SUBJECT: ISSUANCE OF AMENDMENTS - VOGTLE ELECTRIC GENERATING PLANT,
UNITS 1 AND 2 (TAC NOS. M90966 AND M90967)

SAFETY EVALUATION BY THE OFFICE OF NUCLEAR REACTOR REGULATION
RELATED TO AMENDMENT NO. 87 TO FACILITY OPERATING LICENSE NPF-68
AND AMENDMENT NO. 65 TO FACILITY OPERATING LICENSE NPF-81

VOGTLE ELECTRIC GENERATING PLANT, UNITS 1 AND 2

Figure 3.4-2a

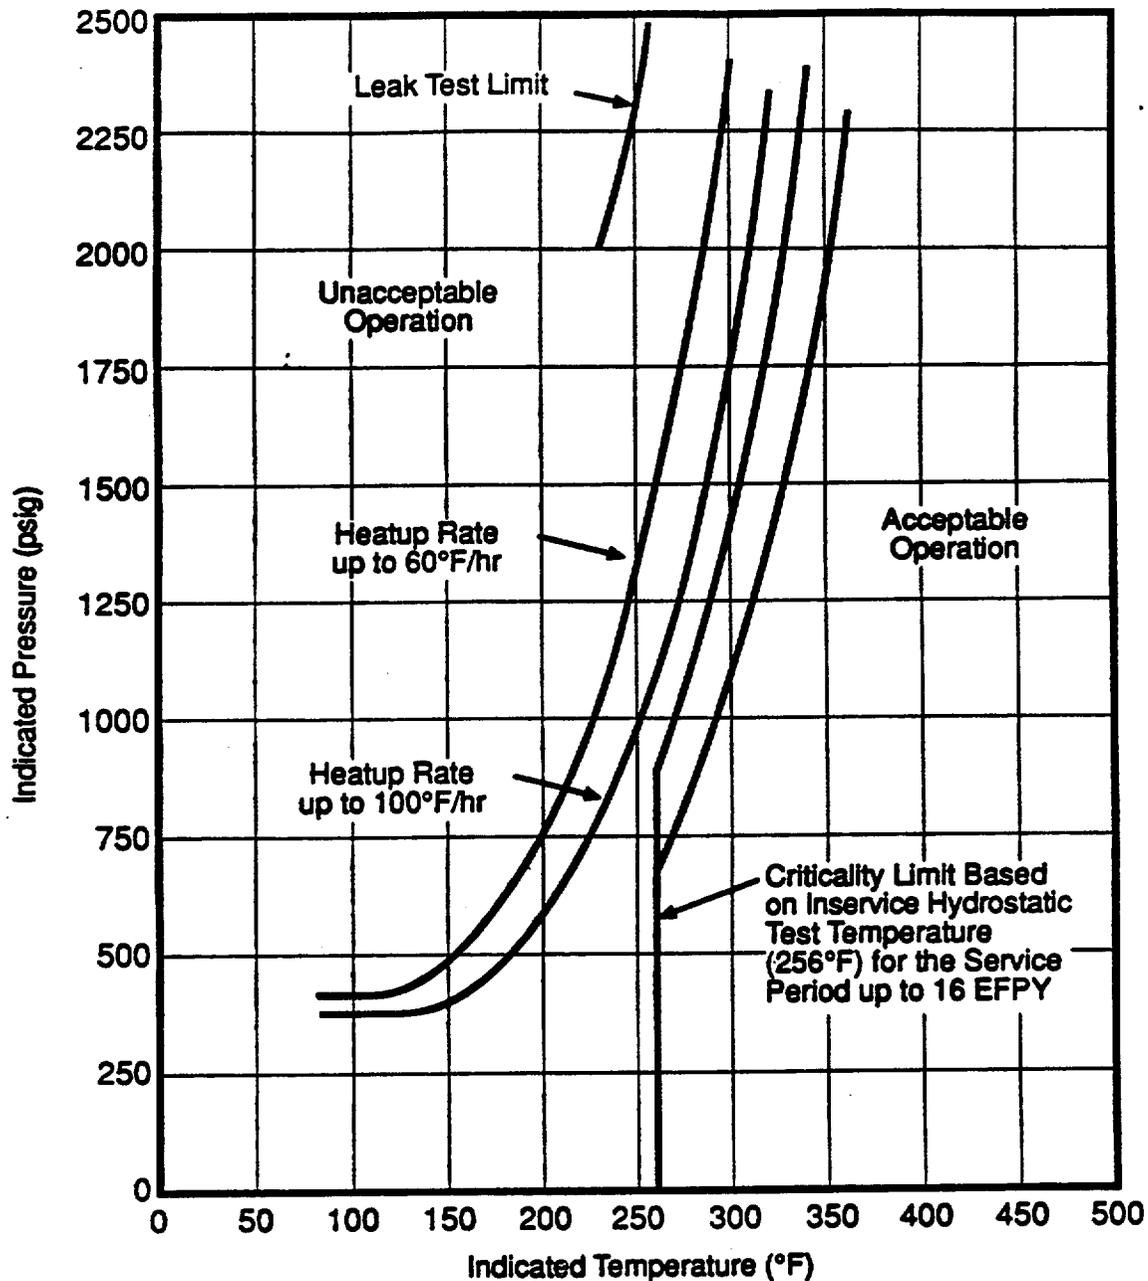
The proposed revisions would replace the current reactor vessel heatup and cooldown curves (TS Figures 3.4-2a through 3.4-3b) with revised curves and would modify the pressure setpoint curves (TS Figures 3.4-4a and 3.4-4b) for the low-temperature, overpressure protection system (LTOPS). In addition, these revisions reflect actions taken by the licensee in response to NRC Information Notice (IN) 93-58, "Non-conservatism in Low-Temperature Overpressure Protection for Pressurized-Water Reactors," and the use of an updated methodology to determine applicable limits in accordance with the provisions of Appendix G to 10 CFR Part 50.

For the Unit 1 reactor vessel, the licensee determined that intermediate shell, B8805-2, is the limiting material for both the $1/4T$ and $3/4T$ locations. The licensee calculated an ART of 100.7°F at the $1/4T$ location and 84.1°F at the $3/4T$ location. For the Unit 2 reactor vessel, the licensee determined that lower shell, B8825-1, is the limiting material for both the $1/4T$ and $3/4T$ locations. The licensee calculated an ART of 112°F at the $1/4T$ location and an ART of 94°F at the $3/4T$ location.

To address the non-conservatism identified in IN 93-58, the licensee has revised TS Figures 3.4-2a through 3.4-3b to include a 74 psi adjustment to the Appendix G pressure limits. This value is the sum of a 4 psi hydrostatic head between the mid-core and hot leg centerline elevations, a 59.1 psi pressure drop due to non-recoverable losses, and a 9.7 psi pressure drop due to fluid acceleration. Pressure drops were calculated between the downcomer (at mid-core level) and the residual heat removal suction line connection to the hot leg (where the wide range pressure transmitter is located). Operation of all four reactor coolant pumps was assumed in this calculation, whereas the TS permit a maximum of three pumps to operate during RCS heatup or cooldown. Accordingly, the calculated pressure drops represent overestimates and the 74 psi adjustment to the P-T operating limits is conservative. We find that the issue identified in IN 93-58 has been adequately addressed by the licensee.

and 10°F incorporated in Figures 3.4-2a through 3.4-3b are not included in the P-T limits used to generate the LTOPS setpoints. Instead, a 27°F uncertainty is applied to these limits when the maximum overpressure is computed for the mass injection event and a 77°F uncertainty (including 50°F for thermal transport) is applied for the heat injection event computation. However, no pressure instrument uncertainty has been applied to these limits. The effect of instrument uncertainty, in general, is considered insignificant in light of the very conservative assumptions used in the development of the Appendix G limits. As such, neither Appendix G nor the ASME Code require that margins for instrument uncertainty be incorporated into the P-T limits. The inclusion of this uncertainty is not needed for ensuring that the operating limits are conservative. The licensee's supplementary submittal dated March 1, 1995, provides data which indicate that margin exists between the revised maximum allowable pressure and the peak pressure attained during the limiting design basis transient for each of the revised LTOPS setpoints. We therefore find the licensee's approach to the development of revised LTOPS setpoints to be acceptable.

Based on an independent analysis to verify the licensee's proposed P-T limits for Units 1 and 2, the staff concludes that the proposed P-T limits for heatup, cooldown, inservice hydrostatic test and criticality are valid for 16 EFY because: 1) the limits conform to the requirements of Appendix G to 10 CFR Part 50 and GL 88-11; and 2) the material properties and chemistry used in calculating the P-T limits are consistent with or conservative compared to data submitted under GL 92-01. Therefore, the proposed P-T limits for Units 1 and 2 may be incorporated in the VEGP Units 1 and 2 TS. In addition, the proposed editorial changes in the Bases section of the TS are consistent with the P-T limits changes and therefore are acceptable.

Figure 3.4-4a
 Unit 1 Maximum Allowable Nominal PORV Setpoint for
 the Cold Overpressure Protection System

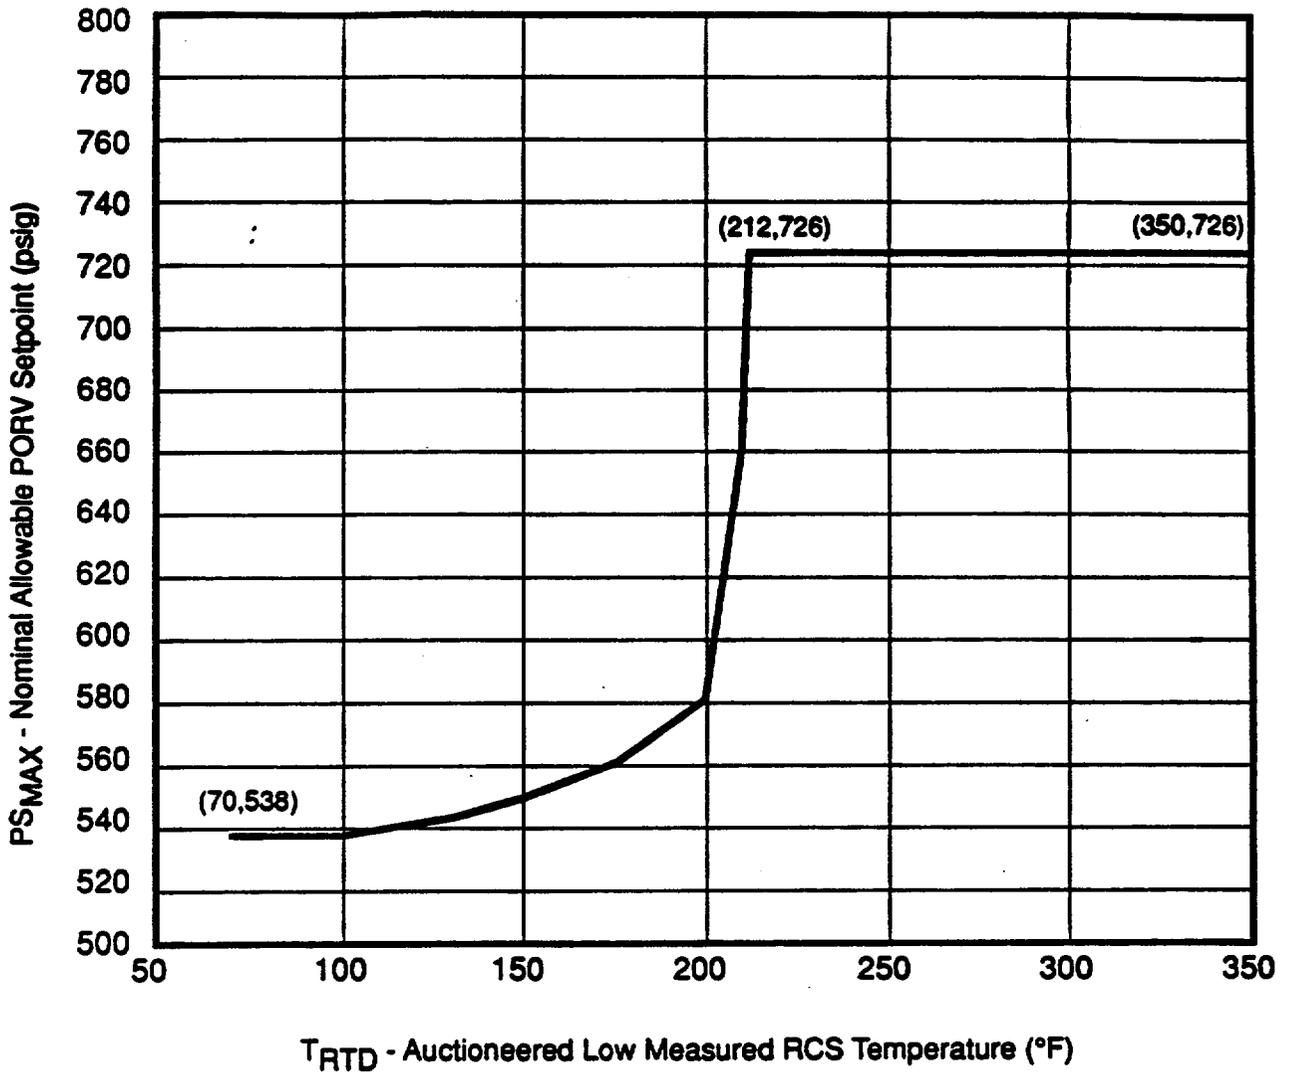
The maximum allowable LTOPS setpoints (Figures 3.4-4a and b) are intended to prevent either the Appendix G limits or an 800 psig limit on the PORV discharge piping (whichever is smaller) from being exceeded during the limiting design basis transients. For purposes of LTOPS setpoint determination, these transients are the mass injection and heat injection events. In generating the revised setpoint curves, the licensee employed P-T limits which differ in several respects from the revised Appendix G curves (Figures 3.4-2a through 3.4-3b) used as plant operating limits. On the basis of ASME Code Case N-514, a 10 percent relaxation of the pressure limit has been applied to the revised Appendix G curves for RCS temperatures up to 200°F. Above temperatures of 140°F and 150°F for Units 1 and 2, respectively, the 800 psig limit on the power-operated relief valve piping becomes limiting. Additionally, the pressure and temperature instrument uncertainties of 60 psi

Based on the above evaluation, we also find that the issue identified in IN 93-58 has been adequately addressed by the licensee and that the revised LTOPS setpoints (TS Figures 3.4-4a and 3.4-4b) are acceptable.
